CITY OF ALBUQUERQUE

PLANNING DEPARTMENT – Development Review Services

RE: New **Hotel**
Conceptual Grading and Drainage Plan
Engineer's Stamp Date 6-20-2014 (File: J13D066)

CONCEPTUAL GRADING
AND DRAINAGE PLAN

SDP-3.1

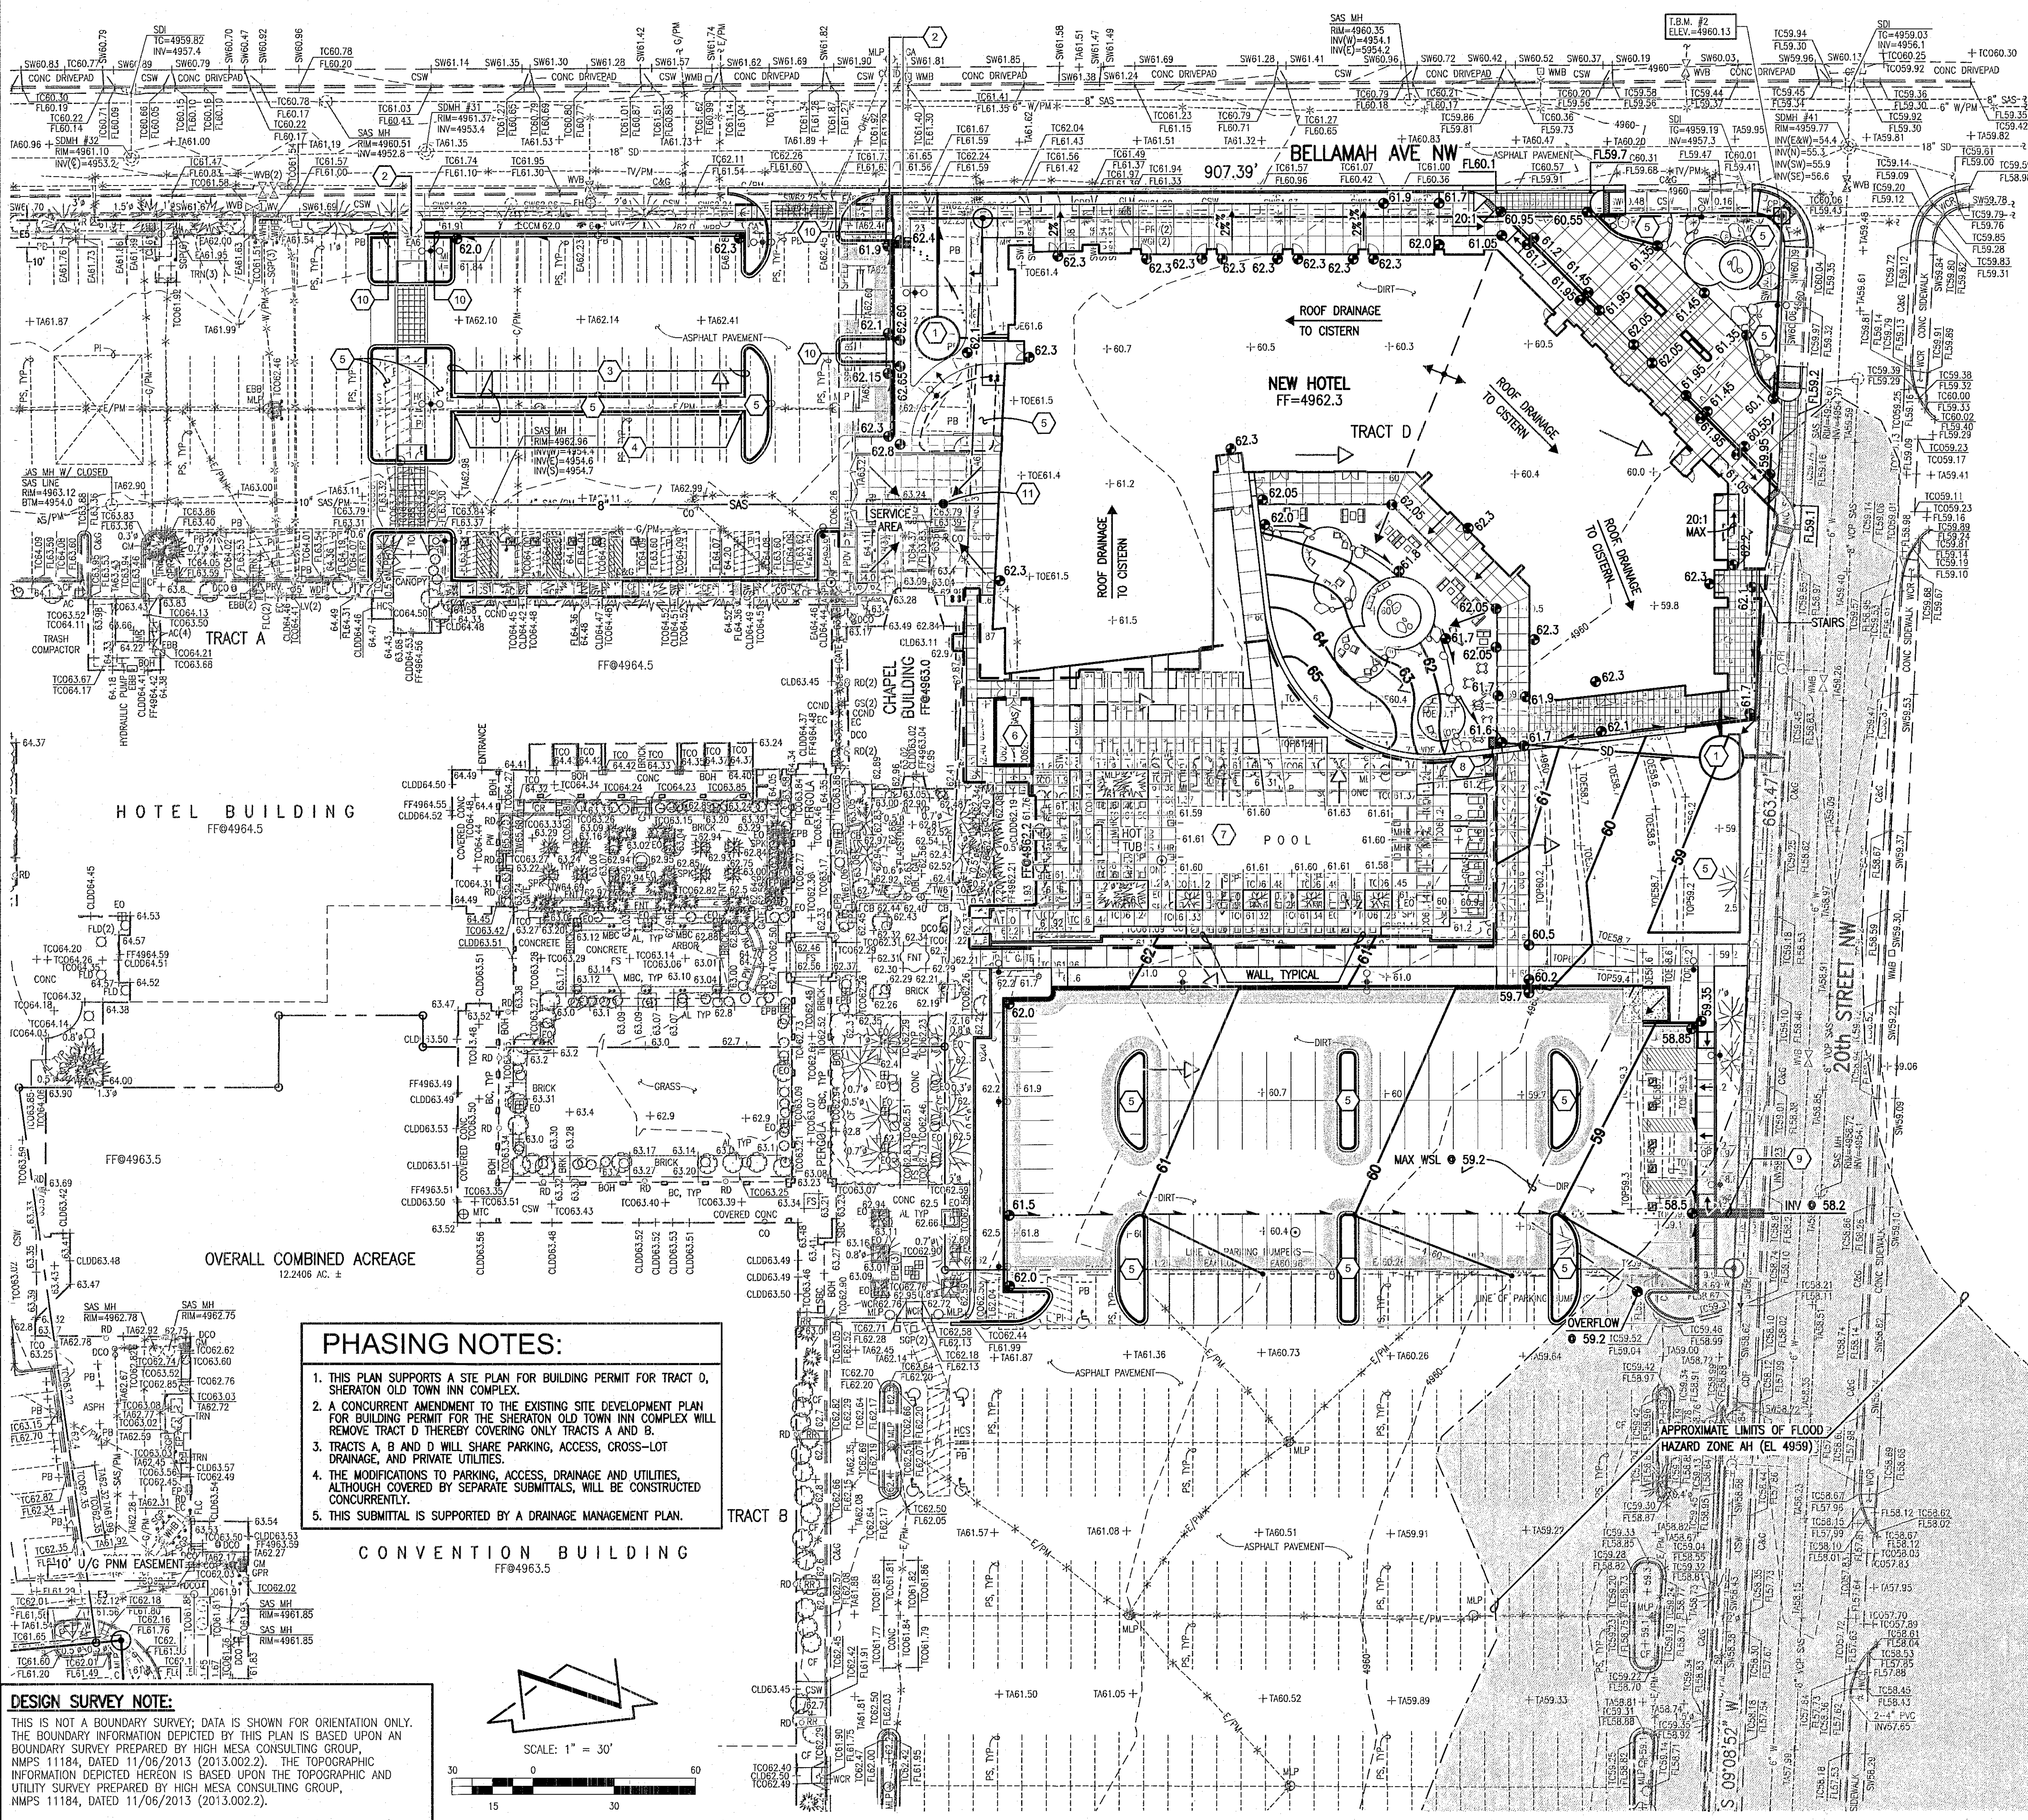
The above referenced **Conceptual Grading and Drainage Plan** received 6-23-14 was submitted in order to support a Site Plan for Building Permit for **Tract D only** of the Sheraton Old Town Inn Complex. It is understood that Tract D is being removed from the existing Site Development Plan by amendment, and will include Tracts A and B only. It is noted that Tracts A, B, and D will share parking, access, cross-lot drainage, and private utilities. Since the **Conceptual Grading and Drainage Plan** is essentially the approved Drainage Management Plan from the Sheraton Old Town Drainage Master Plan (Engineer's Stamp Date 6-23-2014), this plan is also approved for DRB action.
